**A RESOLUTION OF THE CITY COUNCIL OF
THE CITY OF MERCED, CALIFORNIA,
ADOPTING THE MERCED VISION 2030
GENERAL PLAN**

**MERCED VISION 2030 GENERAL PLAN
OPTION 2**

Proposed Changes Since August 2010 Public Review Draft

(*Revised--12/16/2011)

UC Merced Campus & University Community North Land Use Map

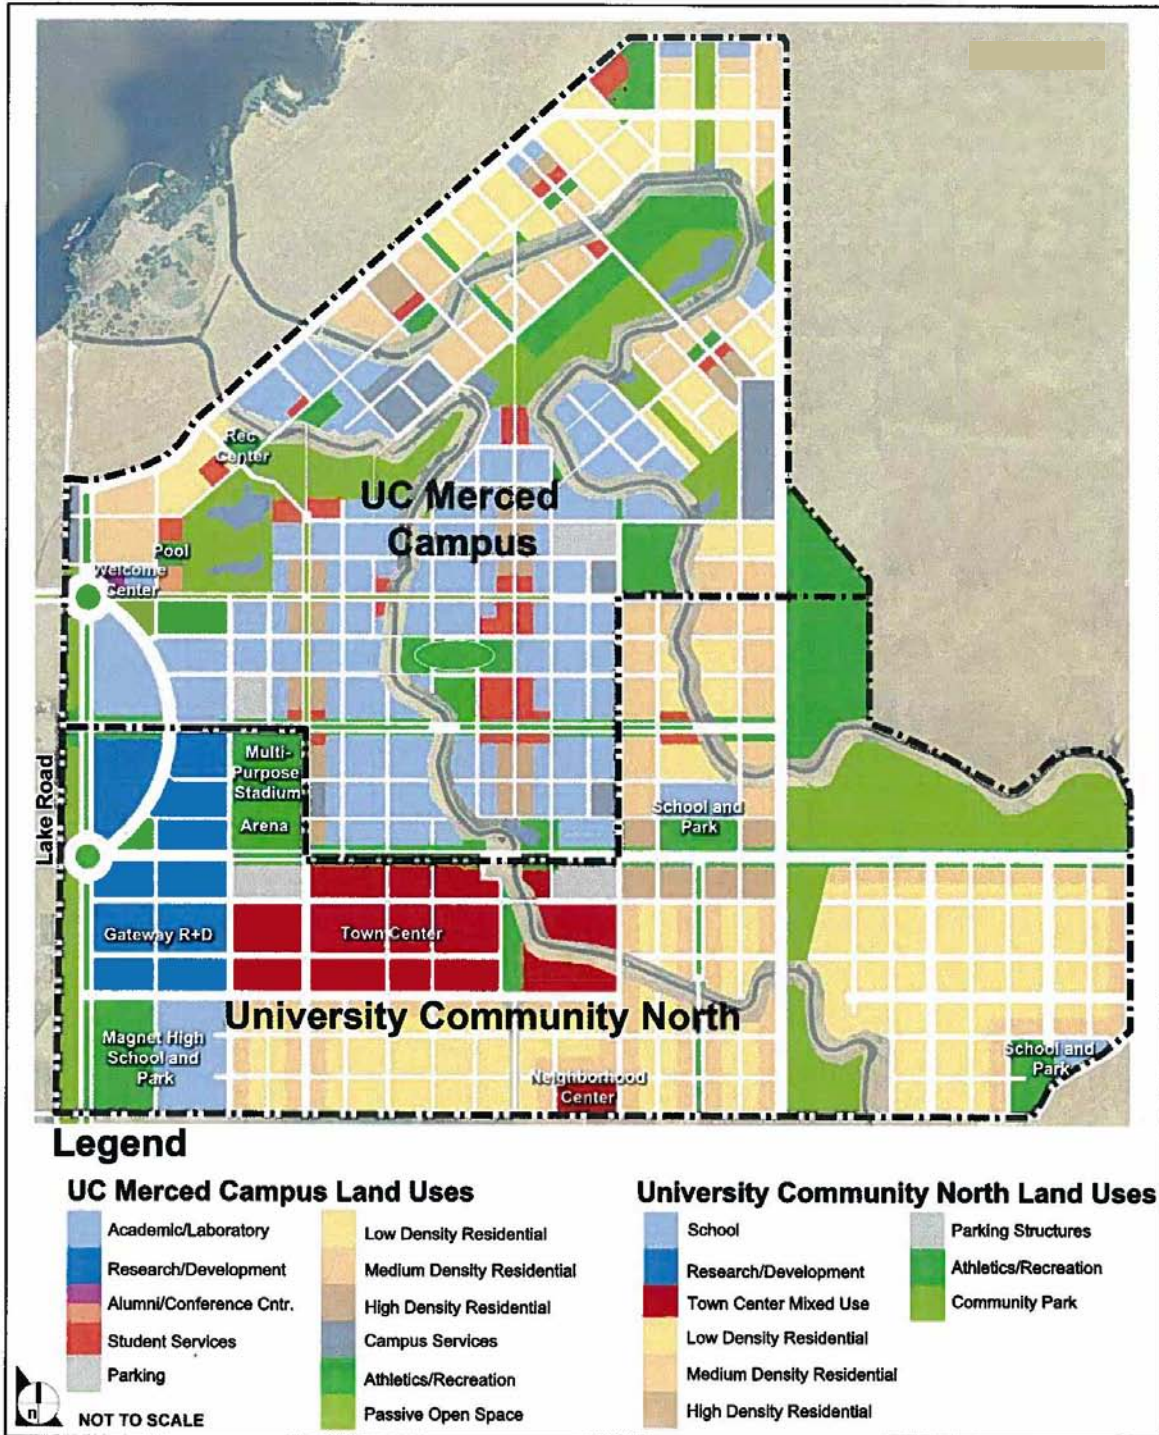
#	Pg.	¶	Col.	Change	Source
1	--	--	--	Various Figures, Maps, and Table throughout the General Plan document will be modified to reflect the 2009 UC Merced and University Community North boundaries as adopted by the UC Board of Regents in 2009. This will include changes to the Land Use Diagram and SUDP/SOI boundary for those areas only. See Exhibit 1 for the 2009 UC/UCP boundaries.	CS/UC

Land Use Diagram - Option 2 Sectors for Adoption

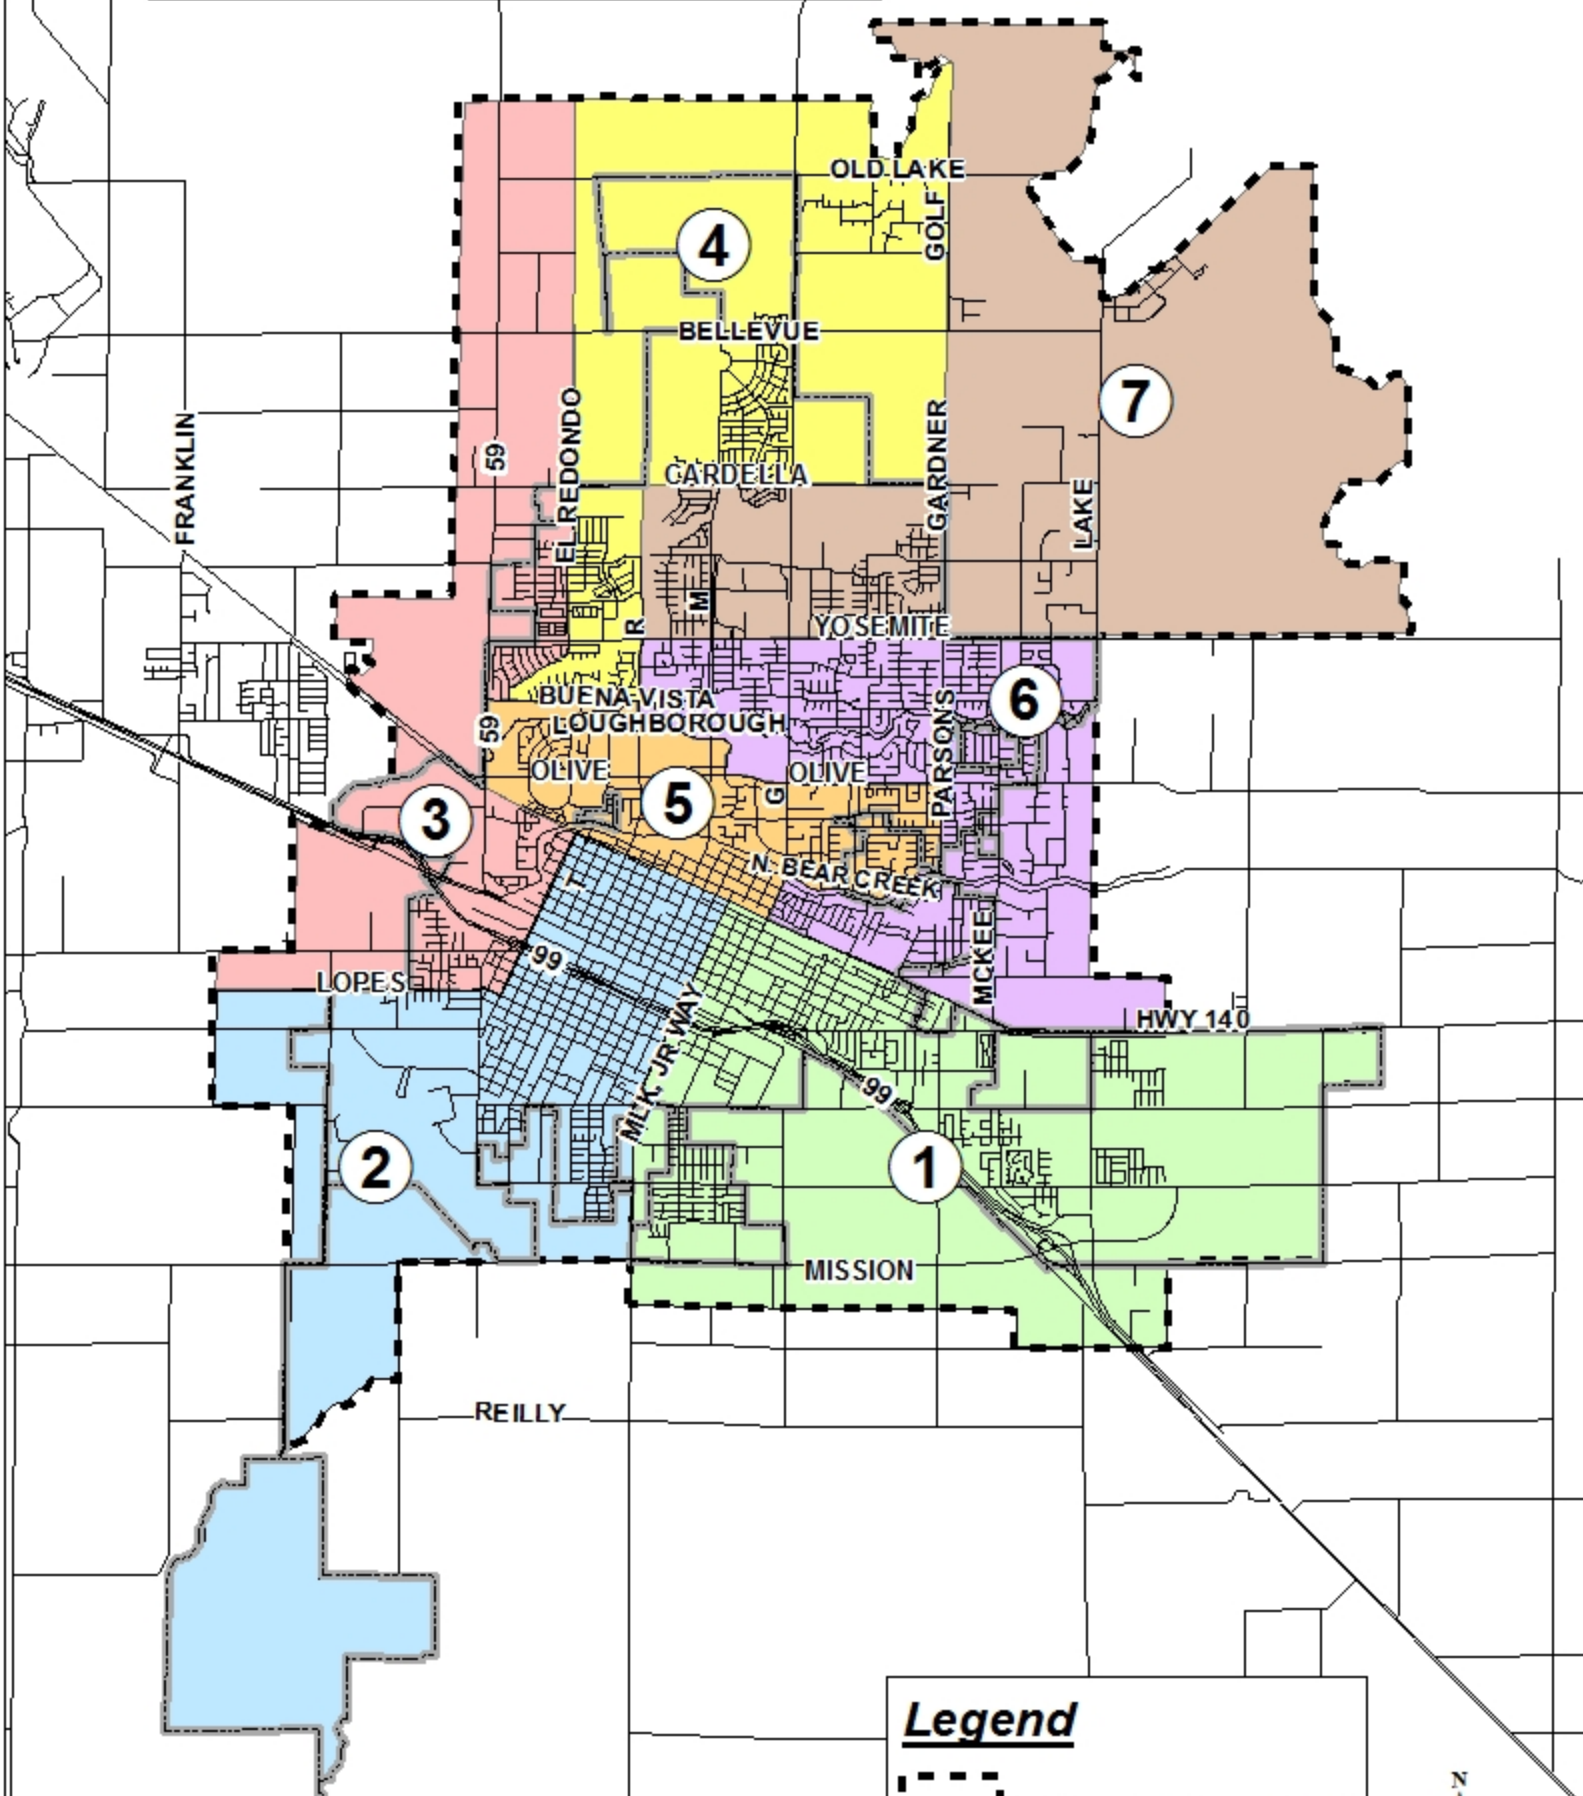
SECTION 3. The *Merced Vision 2030 General Plan* Land Use Diagram (Modified Figure 3.1 of Exhibit A) as divided into the seven sectors outlined in Exhibit D and with the changes as outlined in Exhibit C is hereby adopted.
